Executive Director's Recommendation

Commission Meeting: July 9, 2015

PROJECT Building Expansion John F. Kennedy Center for the Performing Arts 2700 F Street, NW Washington, DC	NCPC FILE NUMBER 7523
SUBMITTED BY John F. Kennedy Center for the Performing Arts	NCPC MAP FILE NUMBER 3.10(64.00)43898
REVIEW AUTHORITY Approval 40 USC § 8722 (b)(1) and (d)	APPLICANT'S REQUEST Preliminary and final approval of site and building plans
	PROPOSED ACTION Approve with comments
	ACTION ITEM TYPE Staff Presentation

Figure 6: Entry Court

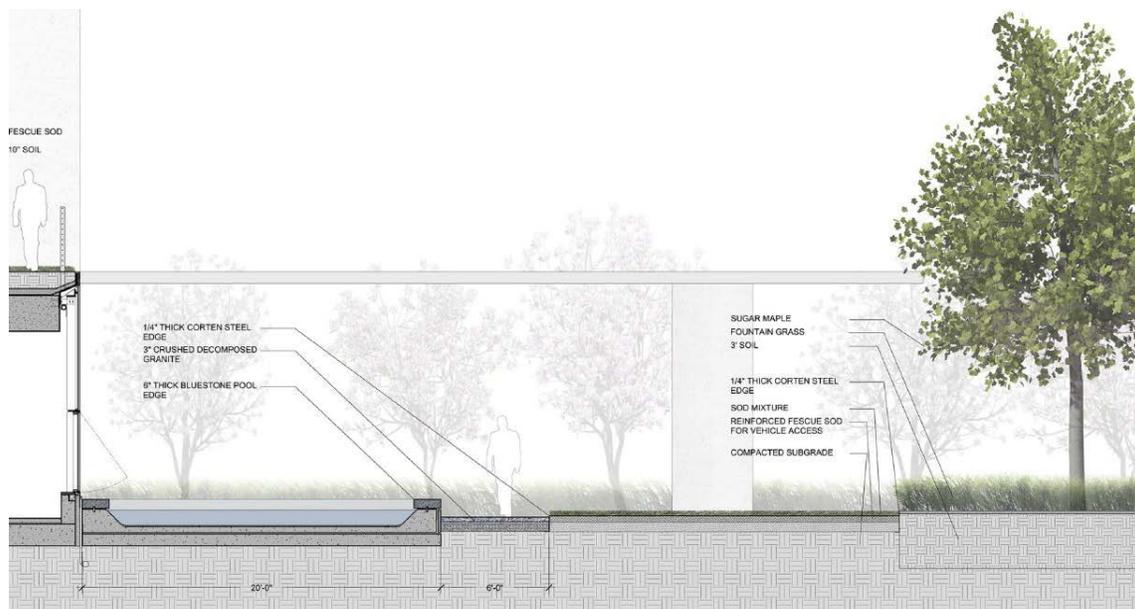
The proposed entry court is the primary entrance for visitors arriving by bus. A pathway will connect this curbside drop-off with the new expansion, and a canopy will cover a portion of this entry. The Kennedy Center will plant several Saucer Magnolias and install a reflecting pond (80 feet long by 20 feet wide by 1 foot deep) adjacent to this entrance. The deck will be accessible via the boardroom and an adjacent six-foot-wide public path. This path will be composed of decomposed, stabilized bluestone. Some Sugar Maples will be planted to the east of the pathway near the pond, which leads to the southern portion of the site connecting to the grove of Ginkgo trees and the outdoor classrooms.

Figure 9: Existing Conditions – Pedestrian Connections

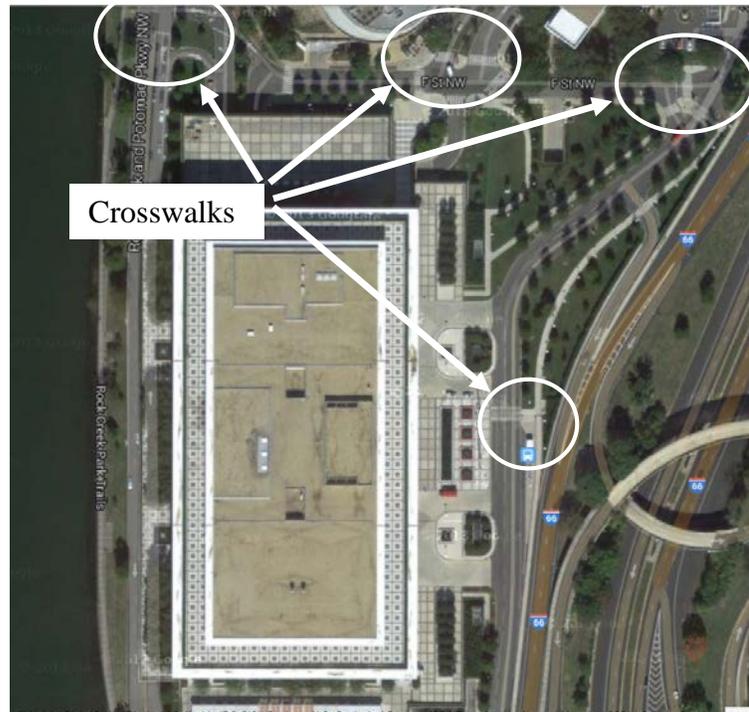
Due to the proliferation of roadways to the west, east and south of the Kennedy Center site, pedestrian and bicycle accessibility to the site is a challenge. There is an at-grade crossing to the RCPP Trail, north of the Kennedy Center, which is available to pedestrians and bicyclists by using a pedestrian-activated signal. There is an existing Capital Bikeshare Station at the Kennedy Center near the front entrance. There are also five locations for bicycle parking on the site as well. The RCPP Trail is a well-used commuter and recreation trail west of the site. The Kennedy Center notes that some bike traffic may result from improving access to the RCPP Trail and that a bike route through the site to ensure the safety of the visitors and bike users is being developed.

There are crosswalks allowing walking visitors from the north to gain access to the Kennedy Center site which can be seen in Figure 9. In addition, a pedestrian connection to the Theodore Roosevelt Bridge pathway is also being strengthened with a formal connection between it and the Kennedy Center.

Figure 11: Floodplain (FEMA Map)

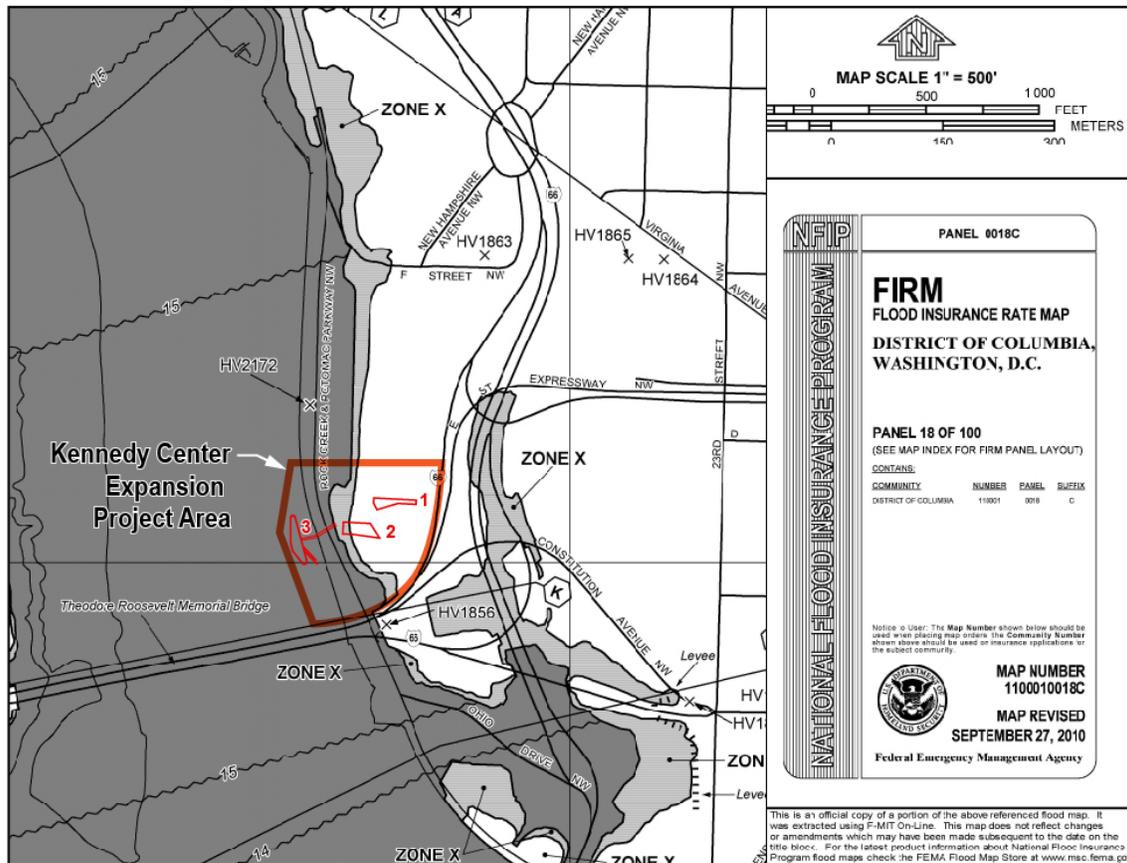
During the December 2014 and February 2015 Commission meetings, the Commission raised an issue about the project being developed on the floodplain (Figure 13). This issue was stressed further with the new Executive Order 13690: “Establishing a Federal Flood Risk Management Standard and a Process for Further Soliciting and Considering Stakeholder Input” which President Obama signed on January 30, 2015.

The environmental assessment report prepared for this project included an evaluation of the floodplain impact. The existing conditions include significant amounts of impervious surface area that consists of existing parking lots and roadways and only a few planted areas. This provides only minor floodplain value. The existing parking garage provides some storage capacity during flood events. The new expansion proposal will continue to provide storage capacity as the garage will continue to be allowed to flood and the new flood storage capacity is being added by allowing the new bus parking area and bus turn around to flood.

Regarding flooding impact, the Kennedy Center notes that during a 100-year flooding event the water would rise to 15 feet. Because the elevation of the bus parking is 11 feet, this area and the bus turn around area would be expected to flood during a 100-year event. Anything greater than a 100-year event floodwater would eventually spill into the underground parking which is at a level of 15.5 feet.

Staff determined the floodplain regulations apply to this project but do not prohibit the development as they only direct federal agencies to “...avoid direct and indirect support of floodplain development wherever there is a practicable alternative.” Staff notes the following:

- The Kennedy Center states that there are no other practicable alternatives for locating the proposed development outside the 100-year or 500-year floodplains.
- The garage and parkway entrance, which is at an elevation below the 100 year floodplain elevation of 15 feet, is designed to allow flooding to mitigate the impacts of developing on the floodplain.
- The below grade levels of the expansion is at an elevation of 15.5 feet and will be waterproofed up to 18.5 feet to protect the finished areas from flooding.
